**Burden of Proof Statement**  
*Response To Incomplete Letter*  
PLLD20220311

**Applicant/  
Owner:** 325 NW Arizona Ave LLC  
Greg Broderick  
180 NW Skyliner Summit  
Bend, OR 97703

**Planner:** Blackmore Planning and Development Services, LLC  
Greg Blackmore  
19454 Sunshine Way  
Bend, OR 97702

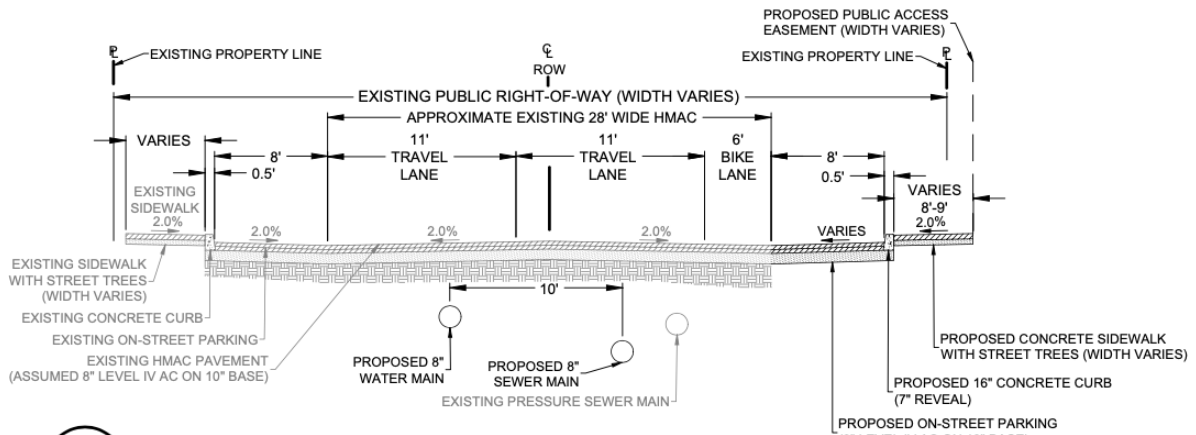
**Mitigation 8: ADA ramps that are compliant with the City of Bend and PROWAG standards will be constructed on the corners of NW Arizona Avenue and Sisemore Street. Where the ramps to the north of Arizona Avenue do not align with the new ramp along the frontage, the northern ramps must be removed and replaced to conform to City standards. A marked crosswalk on the west side of Sisemore Street crossing NW Arizona Avenue will be installed. A luminaire will be installed to illuminate the pedestrian painted cross walk.**

**Mitigation 9: Two access points will be allowed onto NW Arizona Avenue. One access point on the western parcel will align with the entrance to Market of Choice. A second access point will be permitted on the eastern parcel. Both accesses are required to be constructed to City of Bend driveway apron standards and comply with PROWAG standards.**

**Mitigation 10: The new subdivision will provide one shared access point to lot C for the benefit of lots A, B, and D. Lots A, B and D will not have direct access points to NW Arizona Avenue. A shared access isle, 20-feet wide, extended from the east property line to the west property line of lot C without a spite strip will be required. The shared access, isle and no access to NW Arizona Avenue from lots A, B and D will be recorded on the subdivision plat.**

**Response:** It is expected that items 8, 9 and 10 will become a conditions of approval.
